## TOLEDO-LUCAS COUNTY PLAN COMMISSIONS

REF: SUP-1004-19

SUBJECT: Request for an Amendment to Special Use Permit for gas station & convenience store at 3023 Dorr Street.

SITE PLAN

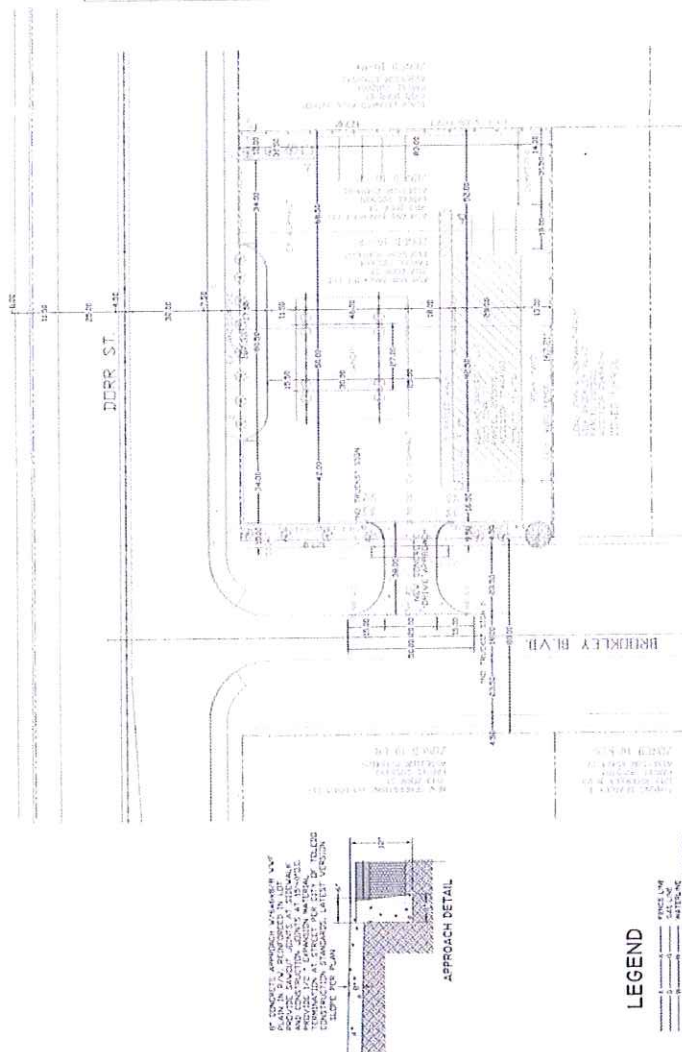
The applicant is requesting the amendment to the Special Use Permit (*SUP-5005-02*) in order to construct a new access drive on Brookley Boulevard. Traffic and safety concerns are cited, by the applicant, as reasons for the proposed drive. Ingress/egress to the site is currently via two access drives off of Dorr Street. A center median stretches along Dorr Street in front of the subject site preventing exiting motorists from making a left (westbound) turn onto Dorr.

Pursuant to TMC§1107.0304 – *Parking, Loading, and Access – Schedule A*, a convenience store with fuel sales is required to have one (1) parking space per pump (count as if parked at pump) plus one (1) parking space per 300 square feet of building area. The submitted plan indicates that a 2,640 square foot building and eight (8) pumps on site; therefore, seventeen (17) parking spaces are required for the site. The site plan submitted indicates that eight (8) parking spaces are available with one (1) at each of the eight (8) fuel pumps, resulting in a total of sixteen (16) parking spaces on site. Staff is satisfied with the existing number of parking spaces on site considering the limited area available for additional parking spaces.

Furthermore, bicycle parking is also required for the convenience store land use. Per TMC§1107.0300 – *Off-Street Parking Schedule "A"*, a minimum number of one (1) bicycle slot shall be provided per ten (10) parking spaces. The minimum number of bicycle parking required on site is two (2) spaces, measured at least two-feet (2') by six-feet (6') per slot. A revised site plan shall be submitted depicting the minimum number of bicycle parking spaces and listed as a condition of approval.

Per the approved conditions and landscaping plan of the existing SUP, a five-foot (5') greenbelt was to be placed along both frontages and maintained indefinitely. The greenbelt was required to have an extensive row of plantings with fifteen (15) shrubs along the Dorr Street frontage, and twenty-one (21) shrubs with four (4) trees along the Brookley Boulevard frontage. Additionally, the approved landscaping plan included a row of seven (7) trees along the southern property line abutting the residential property. Upon site inspection, the landscaping has not been maintained or installed per the approved landscaping plan.

The submitted site plan did not include landscaping improvements or adequately comply with the original approval and therefore not acceptable. A revised landscaping plan shall be submitted depicting plantings per the approved plan and/or compliance with TMC§1108.0200 and listed as a condition of approval.

5. Brookley Blvd is an unimproved, uncurbed street. There is no formal gutter flow line; stormwater drainage flows down the street at the edge of pavement (EOP). A new drive approach on an unimproved street could impede the drainage flow path at the EOP and create a nuisance of stagnant backed up storm drainage. To minimize the chance of creating this condition, be aware that the approach detail showing a raised lip for the concrete approach at the EOP is not required. Rather, the concrete at the EOP can be flush or even set lower compared to the asphalt.

6. Flow at the EOP appears to flow from south to north, from the 98.83 elevation at the southwest corner of the proposed drive approach to the 98.62 elevation at the northwest. The 98.40 elevation in between means that a 2" deep puddle will result in the middle of the approach. Resubmit a minor revision to Engineering Services that shows grading for positive flow across the approach.
7. A catch basin (CB) exists at the corner of Dorr and Brookley. Consider extending a new storm line, or a perforated underdrain from the CB to the south limit of the proposed drive approach to provide drainage for any impounded water that forms there. If such work is added to the project, submit permit drawings for approval to the stormwater engineer.
8. Owner may be required to remove and reinstall the drive approach if nuisance drainage condition results from inattention to above drainage concerns.

17. New driveway needs to be a minimum of 25 feet wide to facilitate two-way traffic per TMC 1107.

18. The right-of-way encroachment permit will not be issued until landscaping has been installed per the original Special Use Permit (*Ord. 684-02*).
19. All lots of the development site shall be combined into a single taxable parcel identification number.
20. All parking spaces reserved for use by persons with physical disabilities shall adhere to the standards outlined in TMC§1107.1700; **acceptable as depicted on site plan.**
21. Bicycle parking slots shall be provided pursuant to Off-Street Parking Schedule "A" (TMC§1107.0300), which requires one (1) bicycle parking slot per ten (10) parking spaces. **A minimum of two (2) bicycle spaces shall be provided and depicted on a revised site plan.**

- a. The approved conditions and landscaping plan for the existing Special Use Permit (*Ord. 684-02*) indicated a five-foot (5') greenbelt was to be installed along both frontages and maintained throughout the year. The greenbelt was to have an extensive row of plantings with fifteen (15) shrubs along the Dorr Street frontage, and twenty-one (21) shrubs with four (4) trees along the Brookley Boulevard frontage. Additionally, a row of seven (7) trees was required along the southern property line abutting the residential property. Upon site inspection, the landscaping has not been maintained or installed per the approved landscaping plan. **A revised landscaping plan shall be submitted depicting plantings per the approved plan and/or compliance with TMC§1108.0200.**
